Technical Journal

Doorhandles exterior, not fully return

REF NO: TJ 25129.3.0	ISSUING DEPARTMENT: Technical Service	CAR MARKET: United States and Canada	
PARTNER: 3 US 7510 Volvo Car USA		ISSUE DATE: 2019-12-19	STATUS DATE: 2019-12-30
FUNC GROUP: 8340	FUNC DESC: Lock, handle	Page 1 of 4

Volvo Car Customer Service	
	TJ Instruction
	TJ No.25129
	Date January 2013 Issue 01
Title	Adjustment to door handles.

Adjustment

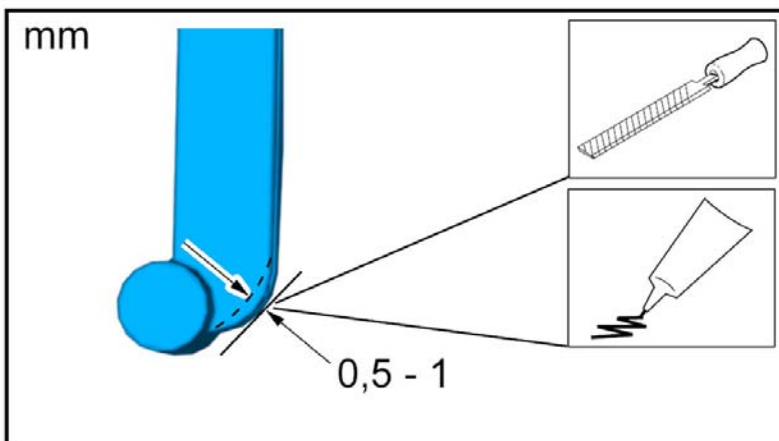
When using outer doorhandle the handle may not fully return to it's original position.

In case of customer complaints, perform adjustment according to attachment.

Use: Grease, 1161761

To install, reverse the removal procedure.
